**Town of Laurel Park
Planning Board**

Title of Item: Site Plan Review – Fawn Turn Lane Lot 3

DEVINE
RESIDENCE

From: Tricia King <ttkdesignstudio@gmail.com>
Sent: Wednesday, January 8, 2025 12:24 AM
To: Kaitland Finkle; Jim Devine; Todd King; Town Manager
Subject: Re: 3 FAWN TURN LANE - Submittal for December LP Planning Board review and approval
Attachments: Devine JAN 7 2025-20 SCALE 24X36 SITE PLAN-1.pdf; Devine JAN 7 2025-20 SCALE 24X36 STORMWATER PLAN-1.pdf; Devine JAN 7 2025-20 SCALE 24X36 LANDSCAPE PLAN-1.pdf

STORMWATER PLAN
Scale: 1"=20'

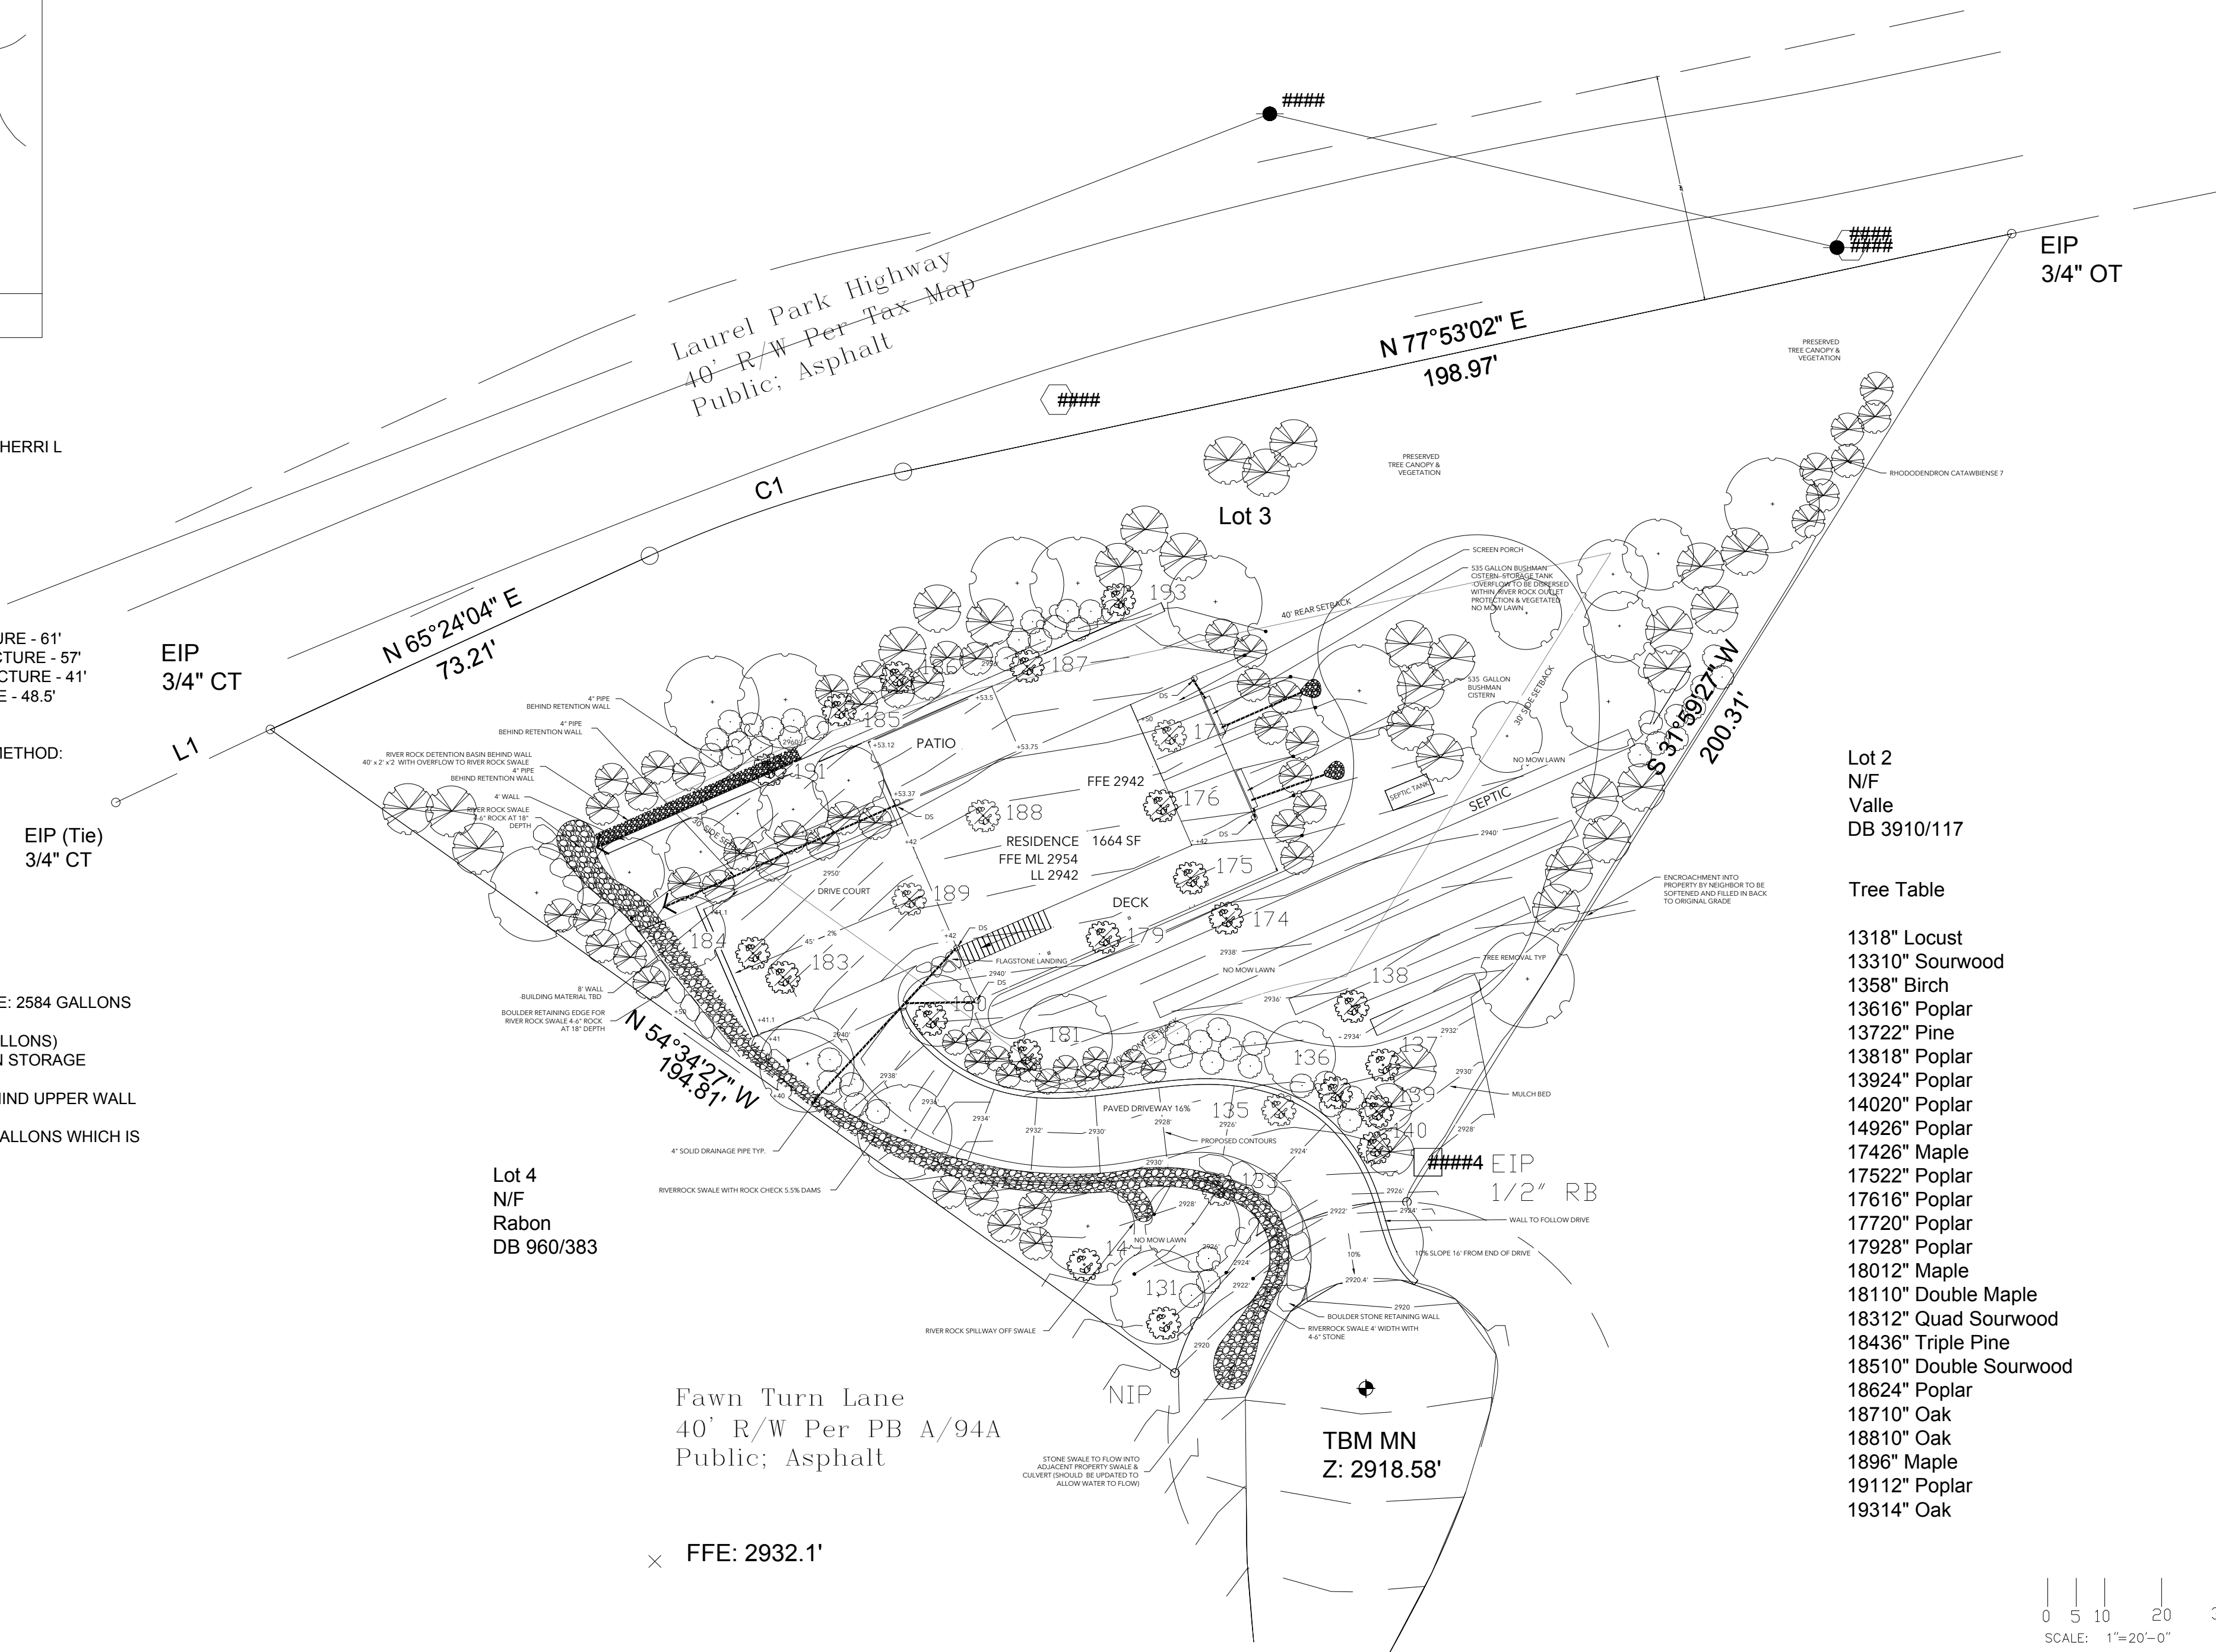
I've had a chance to review the information submitted including stormwater plans prepared by TTK Design and a geotechnical report prepared by Gentry Geotechnical Engineering. The project located at 3 Fawn Turn is considered "steep slope" with a calculated slope of 29% as provided by the landscape architect. The stormwater plan proposes to direct runoff from the driveway and western portion of the house to a river rock swale with infiltration. Runoff from the eastern portion of the house is being directed to two cisterns with overflow from the cisterns being directed to the eastern portion of the property.

Per section 3.1.2:B of the Laurel Park UDO, sites with steep and very steep slopes or geologic hazards are required to disperse stormwater runoff from the site unless such dispersal could increase the possibility of landslide hazards on the site. Overflow from the proposed cisterns appears to be a reasonable approach to dispersal of stormwater. However, the river rock swale on the western side of the site is proposed to include infiltration. This should be addressed between the designer and the geotechnical engineer to confirm how this meets the section of the UDO referenced above. They may be able to use a swale with no proposed infiltration to address this question.

In addition, the geotechnical report does address surface water management in section 9.5 of the report, but it doesn't specifically indicate whether dispersal of stormwater on this site is appropriate. This could be

-The drainage from the proposed river rock swale and driveway is being discharged onto Fawn Turn Lane directly above the driveway for 191 Sweetgum Trail. It is not clear if there is a functional driveway culvert under this driveway. This needs to be addressed by either the property owner at 191 Sweetgum or the owner of 3 Fawn Turn Lane. The drainage from the left side of 3 Fawn Turn Lane will outlet to the new river rock swale at the top of the culdesac and would continue along Fawn Turn Lane just as the neighbors runoff follows the left side of Fawn Turn Lane. The culvert at the drive below should be cleared to function and further investigation to make sure the swale functions.

-The stormwater dispersal from the proposed cisterns on the eastern side of the site appear to flow onto the property at 36 Fawn Turn Lane. We would suggest the designer review this condition to make sure there are no adverse impacts to the property owner at 36 Fawn Turn Lane. The cistern overflow would flow into pipes that outlet onto 3 Fawn Turn Lane and disperse onto their property. It would be dispersed and absorbed in the no mow lawn on 3 Fawn Turn Lane.

Thank you for your patience. I followed up with Jeff at Gentry and have addressed all comments. Attached are the updated drawings that show river rock outlet protection at the cistern overflow areas, removal of infiltration of the river rock swale and notes regarding the ensuring of water conveyance under the neighbors driveway on the left side of the driveway at 3 Fawn Turn Lane. See below:

Jeff Wales (Gentry) agrees that the river rock swale would convey water without infiltration and should be sufficient.

addressed by the geotechnical engineer in an addendum to their report. Jeff Wales (Gentry) addresses surface water management in the report and I talked to Jeff about the types of dispersal and he agreed that the cistern dispersal into river rock protection outlets with vegetation is appropriate.
